**IBM System Storage SAN Volume Controller**

# **Service Guide - Errata**

**Version 4.2.0**  
**August 15, 2007**

GC26-7901-01-Errata

*Four Node SAN Volume Controller, with Redundant AC Power feature, mains wiring*

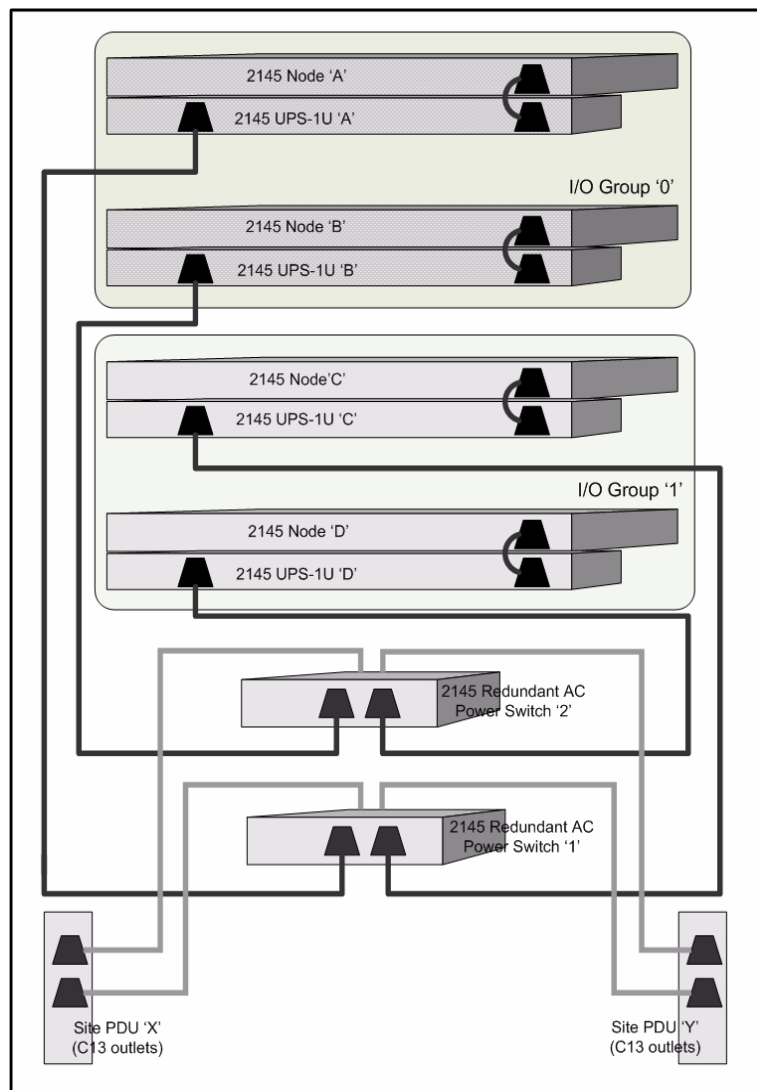
*Page 66. Add this new section.*

The diagram shows the mains power connections in an example installation. This example shows a four node cluster, there are two I/O groups; I/O group '0' contains nodes 'A' and 'B', I/O group '1' contains nodes 'C' and 'D'. In this example only two redundant ac power switches are used; each powers one node in each I/O group. [For maximum redundancy four redundant ac power switches would be used, each powering a single node.]

Note that the diagram is included to show an example of the cable connections; it does not show a suggested physical location for the components.

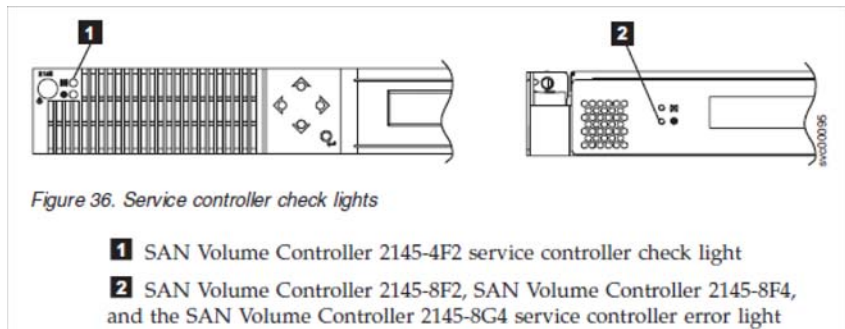
Page 258. Replace Step 9

**Is any SAN Volume Controller front panel showing an error?** There is an error if any of the following conditions are true for the node:

- none of the LEDs on the front panel are on and the front panel display is blank.
- the node is a SAN Volume Controller 2145-4F2 and the check LED on the front panel is on.
- the node is a SAN Volume Controller 2145-8F2, a SAN Volume Controller 2145-8F4 or a SAN Volume Controller 2145-8G4 and the error LED on the front panel is on.

Figure 45. Viewing Nodes

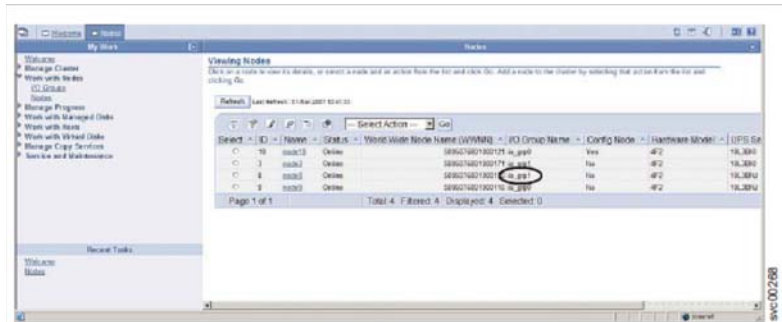
1. Sign on to the master console as an administrator and then launch the SAN Volume Controller Console for the cluster that you are servicing.
2. Click **Work with Nodes** -> **Nodes** in the My Work pane and click on the submenu that opens. The Viewing Nodes panel is displayed. Find the node that you are about to shut down and write down the name of the I/O group it belongs to. Confirm that the other node in the I/O group is Online.

If the node that you want to power off is shown as Offline, then the node is not participating in the cluster and is not processing I/O requests. In these circumstances, you must use the power button on the node to switch the node off.

If the node that you want to power off is shown as Online but the other node in the I/O group is not Online, powering off the node impacts all the hosts that are submitting I/O to the VDisks that are managed by the I/O group. Try to get the other node in the I/O group Online before continuing.

Figure 47. Virtual disks status

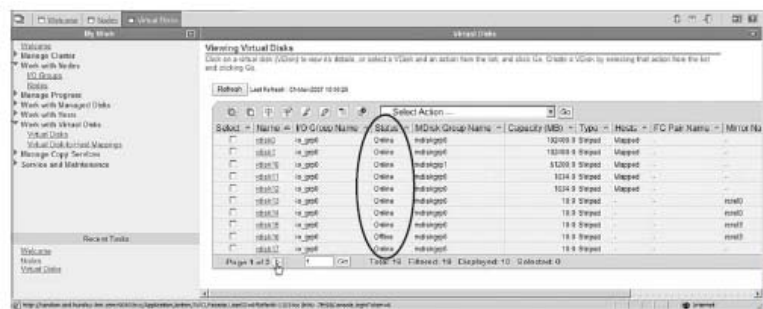
4. Open the **I/O Group** drop down menu and select the I/O group that you wrote down in step 2 on page 286 for the node. Then click **OK**. The list of virtual disks in the I/O group is displayed. Check that the status of each virtual disk in the I/O group is Online; you might need to view more than one page.

If any VDisks are shown as degraded, only one node in the I/O is processing I/O requests for that VDisk. If that node is powered off, it impacts all the hosts that are submitting I/O to the degraded VDisks.

If any virtual disks are degraded and you believe this might be because the partner node in the I/O group has been powered off recently, wait until a refresh of the screen shows all the virtual disks online. All the virtual disks should be online within thirty minutes of the partner node being powered off.

Figure 48. Shut Down a Node

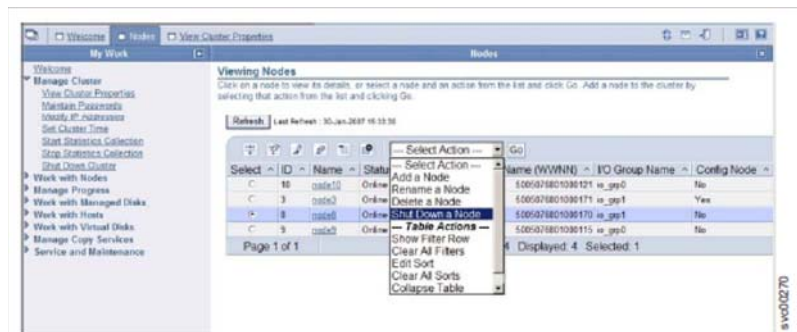
5. If you have decided it is okay to continue and power off the node, click **Work with Nodes** -> **Nodes** in the My Work pane. The list of nodes in the cluster is displayed. Select the node that you are powering off and select **Shut Down a Node** from the drop down list.

During the shut down, the node saves its data structures to its local disk and destages all the write data held in cache to the SAN disks; this processing can take several minutes.
